Your ref: SSD-13895306 Our ref: DOC22/312059

Further to your request for further flood assessment of the Newcastle Grammar School – Park Campus (SSD-13895306) proposal. Water Floodplain and Coast officers have reviewed the response to submissions and provide the following information *without prejudice* for your consideration. (Please note that detailed comments are provided at Attachment A

Newcastle Grammar School – Park Campus Stage 1

Detailed comments - Response to Submissions for City of Newcastle

11/02/2022 Flooding at the site

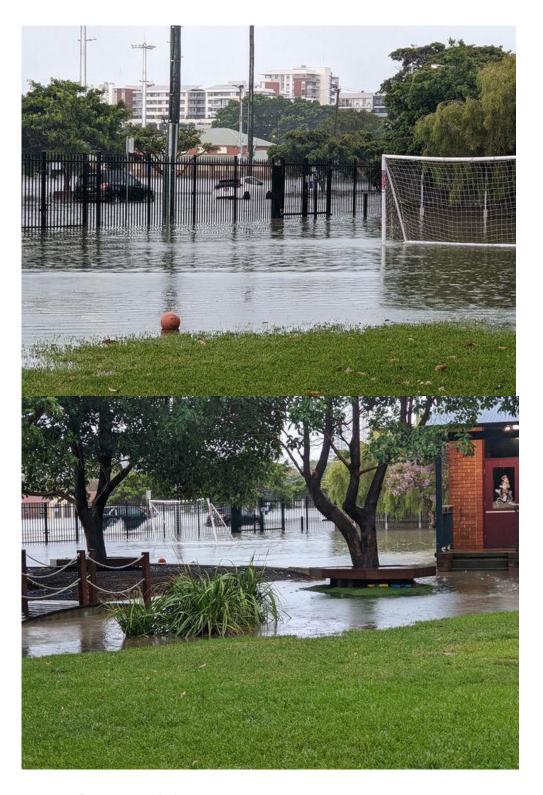
5.The proponent has not provided documentation demonstrating compliance with the with flood safety provisions in their existing Flood Emergency Response Plan

The proponent has not provided evidence of compliance with their existing FERP, as requested by BCD in its submission, dated 21/12/2021.

BCD also requests that the proponent provides documentation of their flood management on the 11 Feb 2022 where flood levels reached between 2.4 and 2.5 AHD.

Recommendation 6

BCD requests that the proponent provide evidence as to the measures taken to date to implement flood safety provisions in their existing FERP, including:

- revision history of the 1988 FERP
- documentation of the school's emergency management response during the June 2007, April 2015 and Feb 2022 floods.
- history of flood evacuations drills
